Attachment 1 Stakeholder feedback template

This template has been developed to enable stakeholders to provide their feedback on the proposed service points, zones and, where relevant, pipeline segments for the initial set of facilities that are expected to be subject to the reforms. The template also contains a number of specific questions that AEMO and the GMRG would like feedback on.

20. Tasmanian Gas Pipeline:

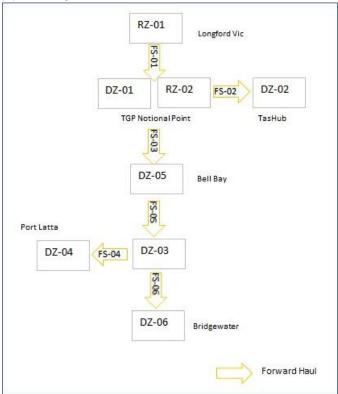
36. No, we do not agree. This is because the current proposal suggests a physical reverse flow, which the TGP cannot provide. Please see diagram below with updated pipeline segments.
